ADDENDUM NO. 3

REYNOLDSBURG CITY SCHOOLS
L.F.O. ATHLETIC & ECO LAB PROJECTS

Date: **March 31, 2011**

Addendum No. 3 to the Drawings and Project Manual, dated **March 17, 2011**, for **L.F.O. ATHLETIC & ECO LAB PROJECTS**, Reynoldsburg City Schools, 7244 East Main Street, Reynoldsburg, Ohio 43068; as prepared by Moody Nolan, Inc., 300 Spruce St. Suite 300, Columbus, OH 43215.

ISSUED WITH ADDENDUM 3	SHEET REVISED CI3.1
SKETCH NUMBER C-SK05	
PROJ # 08177.1	DRAWN BY MAB
DATE 3/30/11

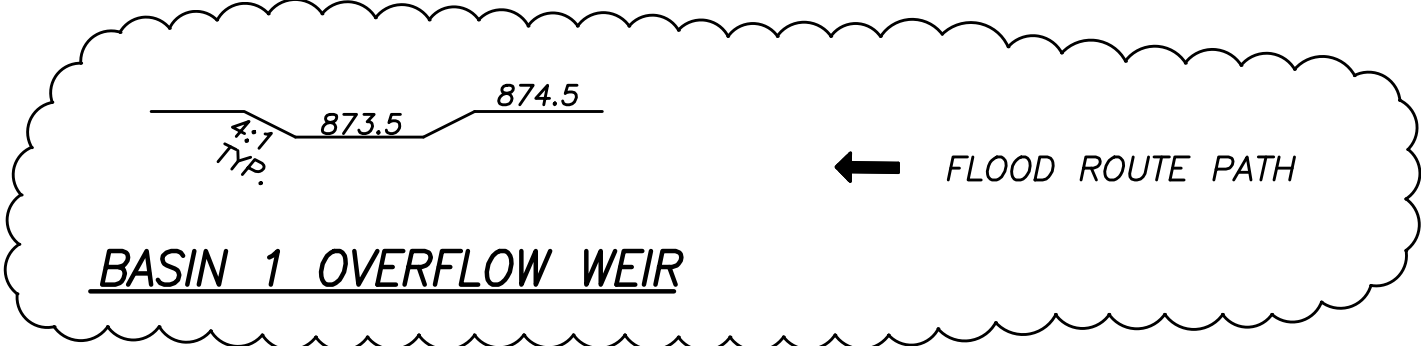
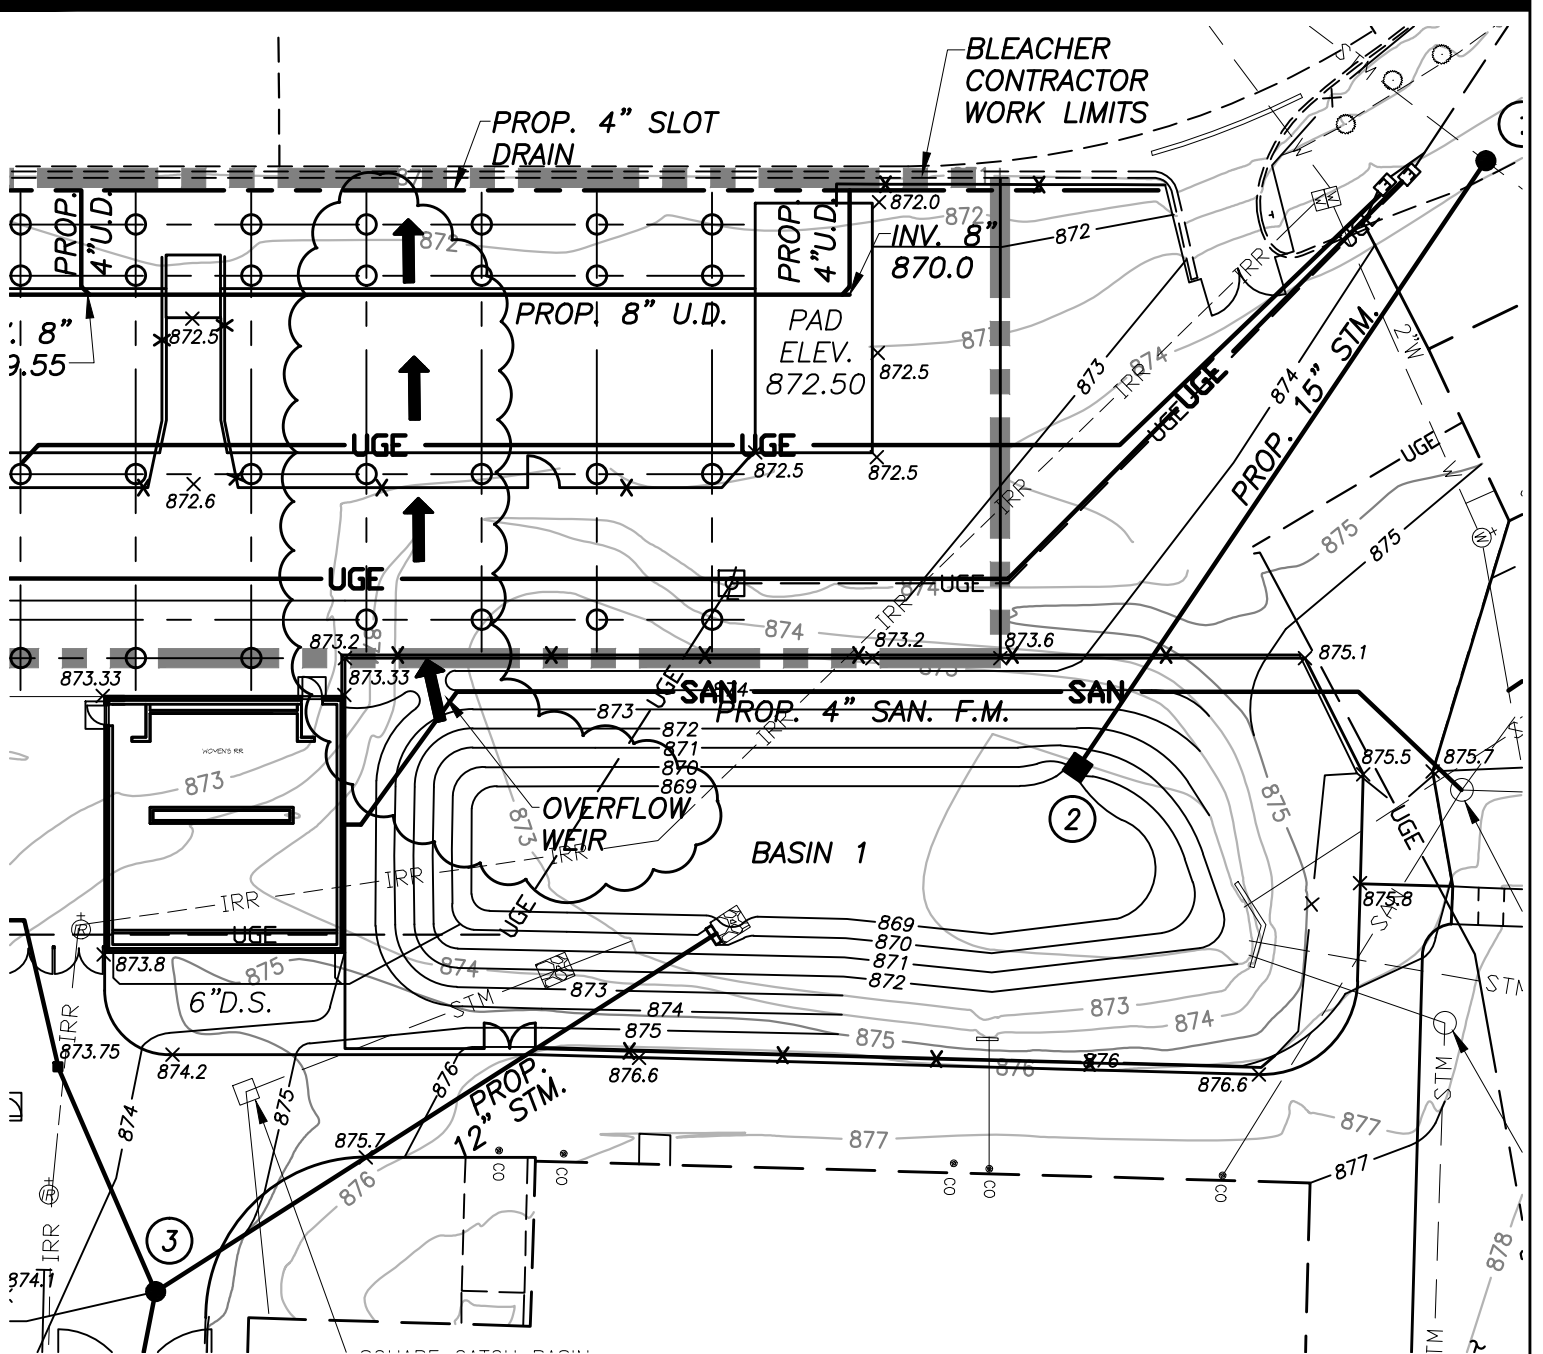
- Item 2-9 Drawing CI3.1
ADD pavement repair areas, add Coded Note 8, revise Coded Note 1. See sketches C-SK04 & C-SK05.
- Item 2-10 Drawing CI5.3
REVISE Detail 15 Release Structure, see sketch C-SK06.

- ① STARTING POINT FOR PRACTICE FIELD IRRIGATION SYSTEM. RE-ROUTE IRRIGATION TO PRACTICE FIELD SOUTH OF THE NEW PARKING LOT & INTO NEW STORAGE ROOM, PROVIDE ALL NECESSARY PIPING AND FITTINGS.
- ② EXISTING CATCH BASIN TO BE ADJUSTED TO GRADE, NEW T.C. ELEV. 874.7
- ③ EXISTING CLEANOUTS TO BE ADJUSTED TO GRADE, PROVIDE NEW FRAME AND LID AS NEEDED.
- ④ 5'x4'x18" ROCK CHANNEL PROTECTION, TYPE C WITH FILTER.
- ⑤ REMOVE EXISTING 12" STORM PIPE BACK TO PROPOSED GRADE 872.6
- ⑥ DRAIN BASIN T.C. = 873.75
4" W & 6" E INV. = 872.0
- ⑦ EXISTING 8" STORM TO BE ABANDONED.
- ⑧ PROPOSED UNDERGROUND ELECTRIC BY OTHERS.

ISSUED WITH ADDENDUM 3	SHEET REVISED CI2.1
SKETCH NUMBER C-SK07	
PROJ# 081TT.1	DRAWN BY MAB
DATE 3/30/11

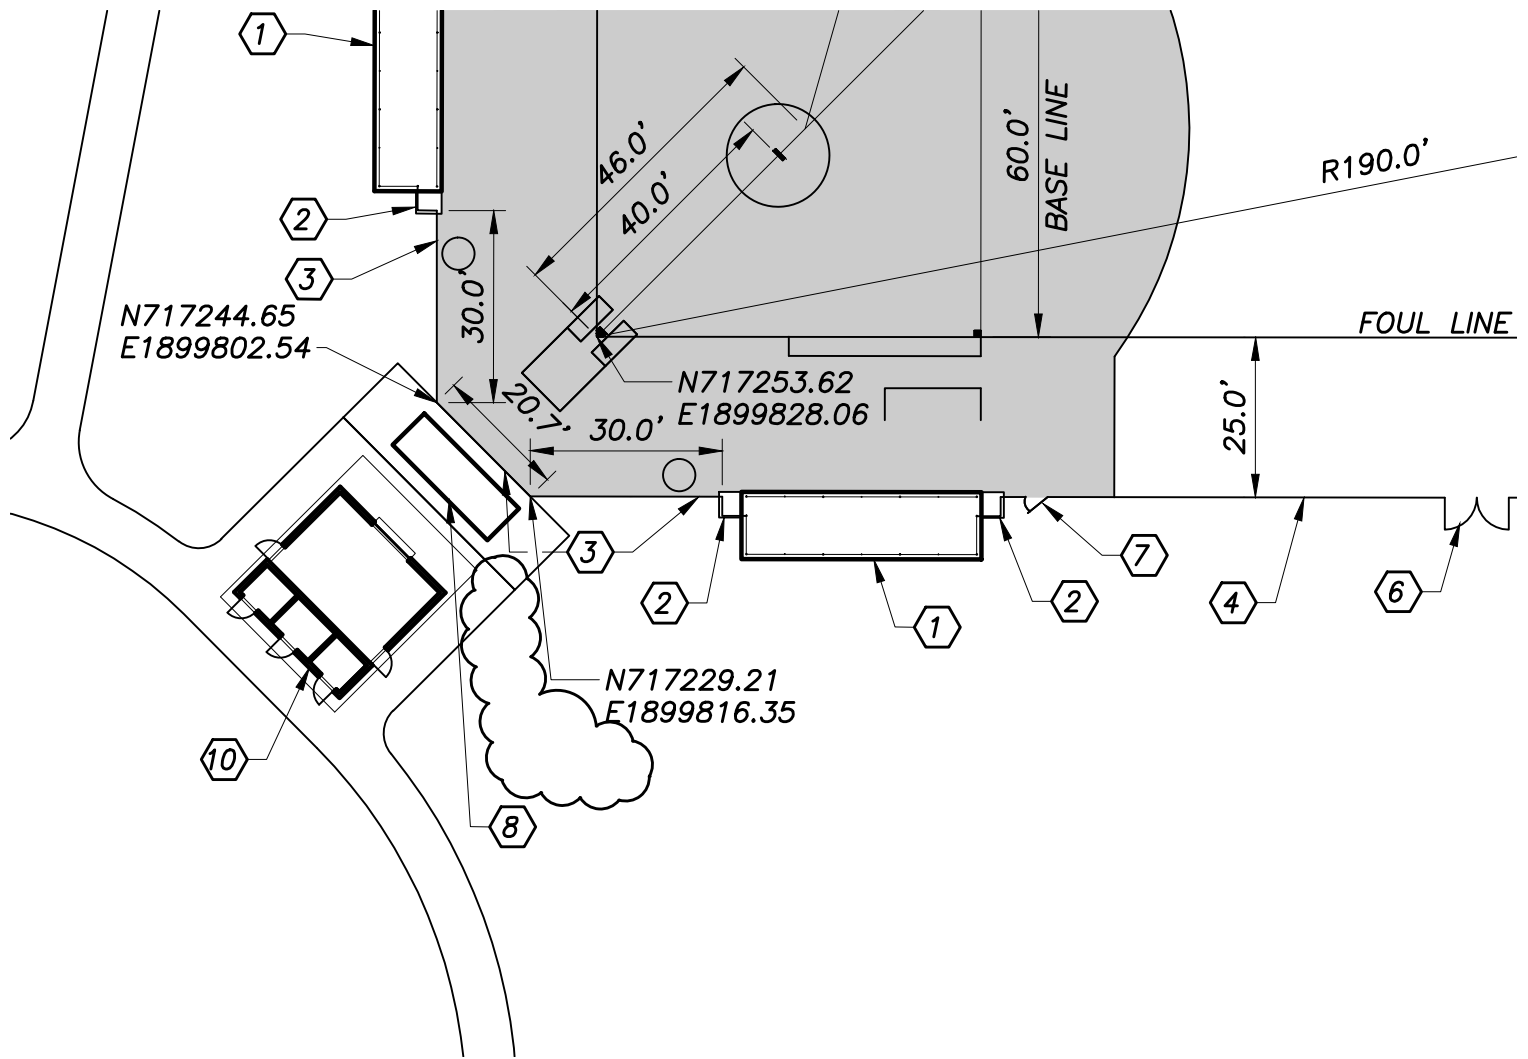
- Item 2-7 Drawing CI1.6
ADD new drawing Signage Plan
- Item 2-8 Drawing CI2.1
ADD basin overflow weir callouts and details, see sketches C-SK07 & C-SK08.

C-SK11

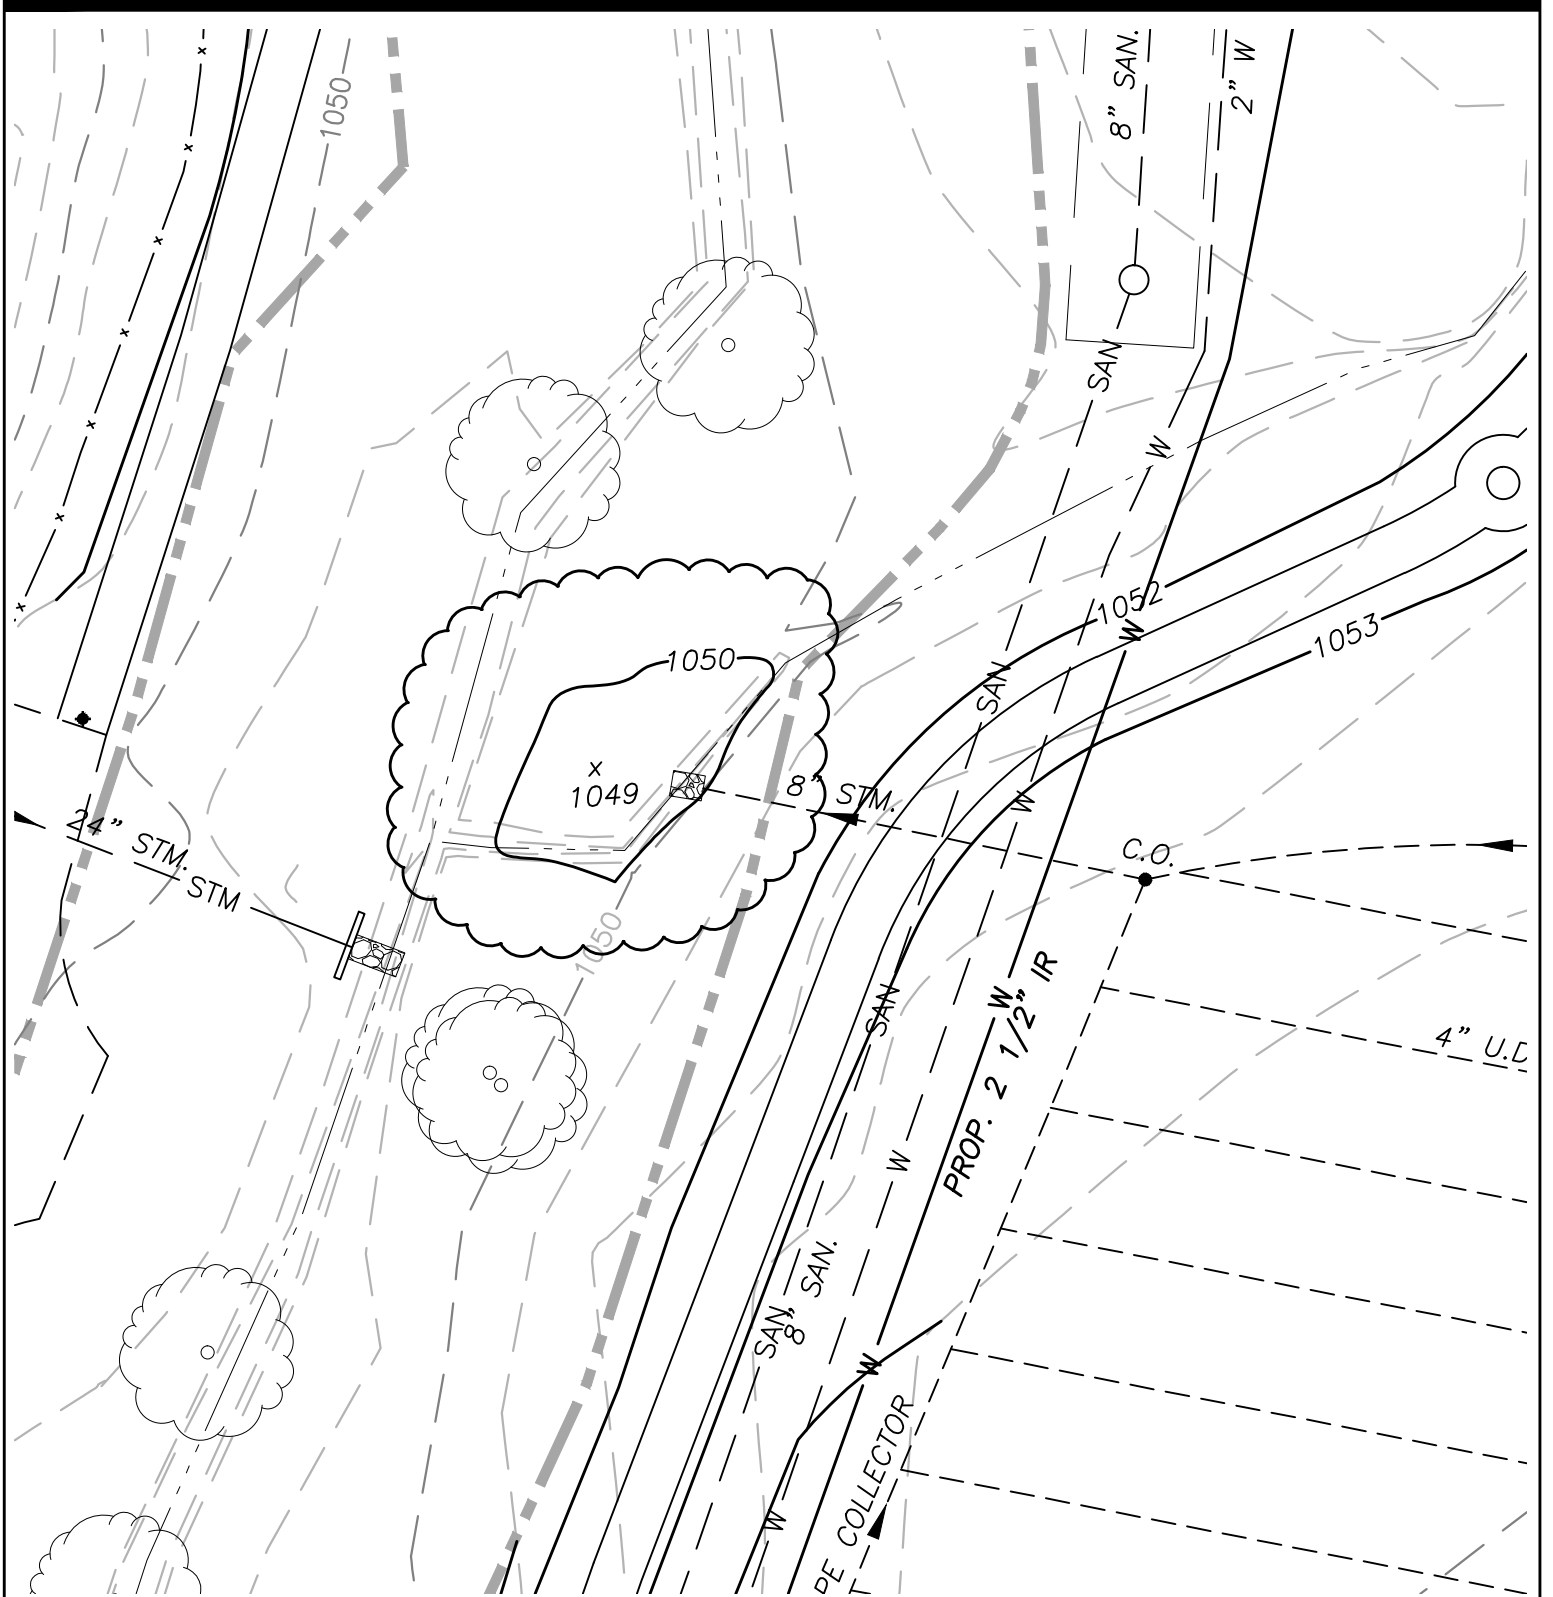
- Item 2-11 Drawing Cs1.2
REVISE location and size of Pipe Double Swing Gate, see sketch C-SK13.
- Item 2-12 Drawing Cs1.3
REMOVE coded note 7 callout from softball plan. Revise Tennis Court Surface to By Owner. Revise Coded Note 9. See sketch C-SK11.

TENNIS COURT SURFACE, BY OWNER

- ⑤ 3' COATED CHAIN LINK DOUBLE SWING GATE
- ⑥ 5' COATED CHAIN LINK DOUBLE SWING GATE
- ⑦ 3' COATED CHAIN LINK SINGLE SWING GATE
- ⑧ BLEACHERS, SEE ARCHITECTURAL PLANS, SHEET Af1.1
- ⑨ 10' GREEN COATED CHAIN LINK FENCE, POSTS TO BE CORE DRILLED
- ⑩ CONCESSION BUILDING, SEE ARCHITECTURAL PLANS, SHEET Ad1.1

SKETCH NUMBER C-SK12

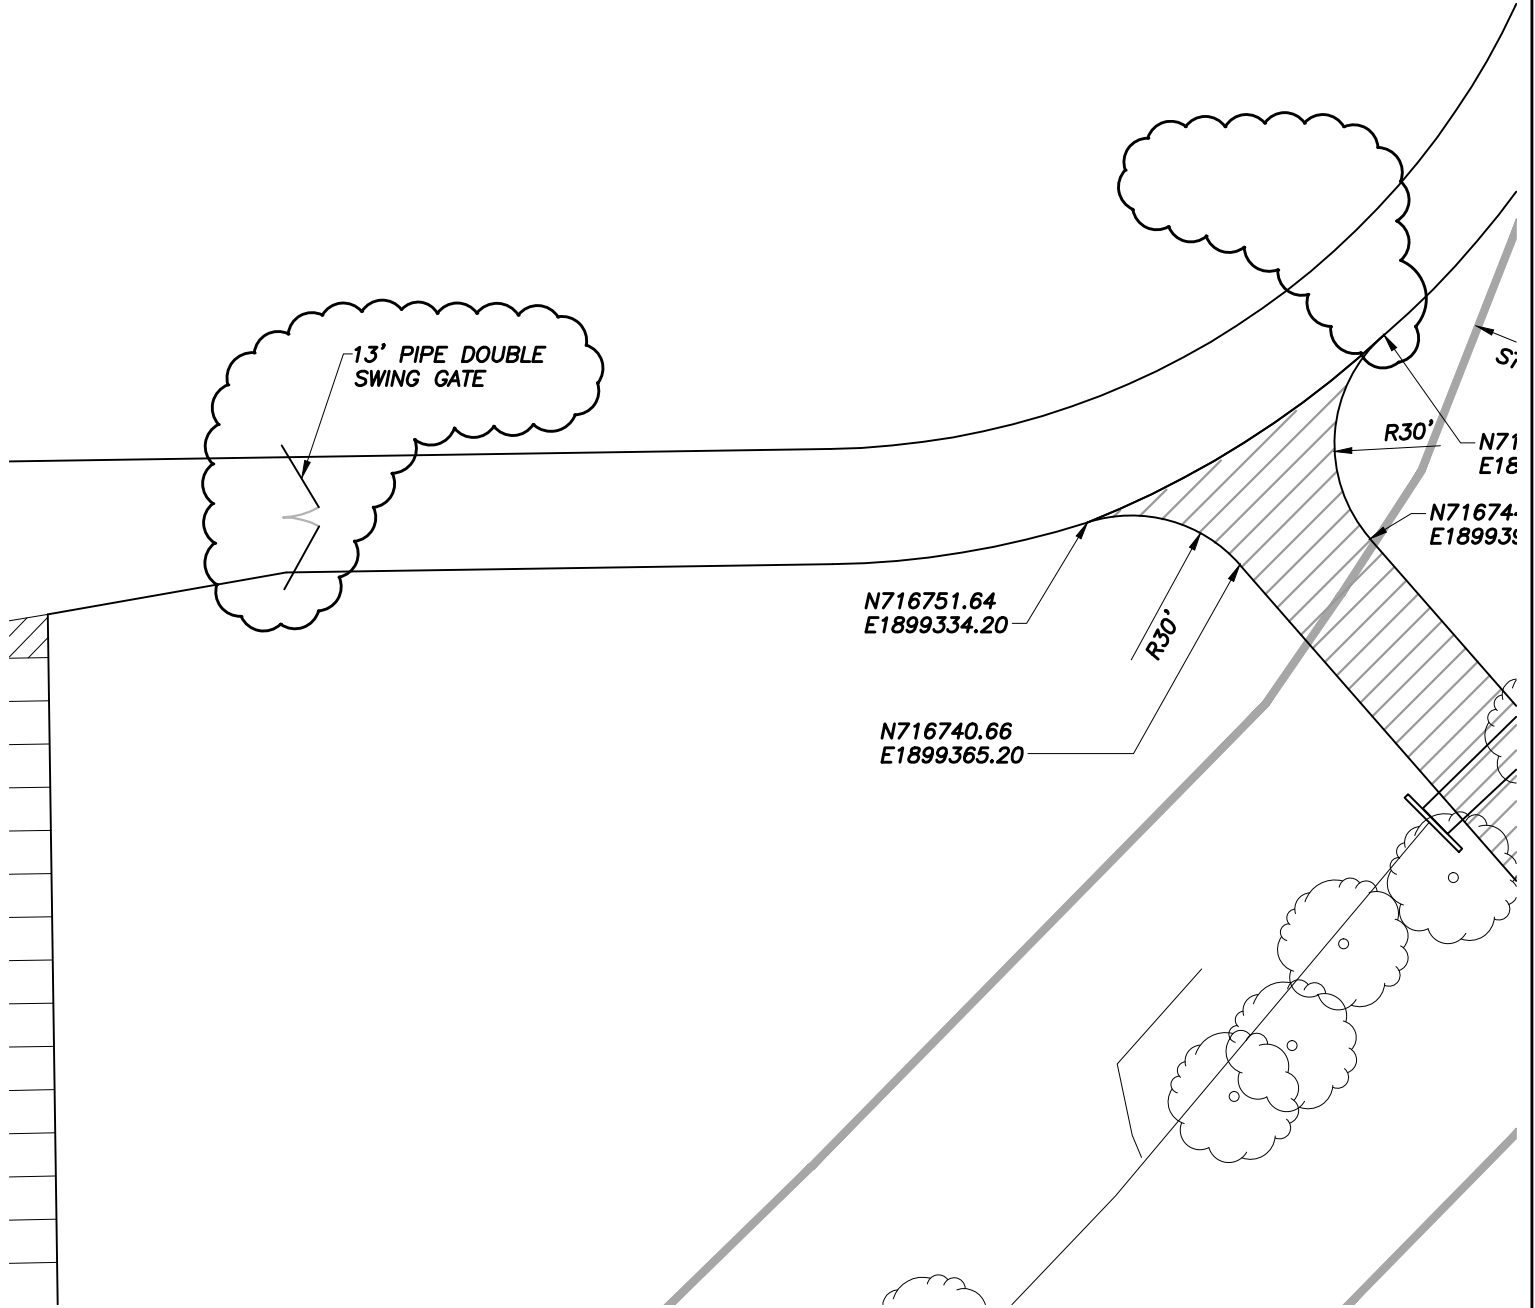
- Item 2-13 Drawing Cs2.1
REISSUE sheet.
- Item 2-14 Drawing Cs2.1
Coded note 3
DELETE "Rated for 40 to 50 GPM @"
ADD "See specifications for pump sizing"
- Item 2-15 Drawing Cs2.2
ADD riparian vernal pool, see sketch C-SK12.
ADD topsoil stockpile and spoil area, see sketch C-SK15.
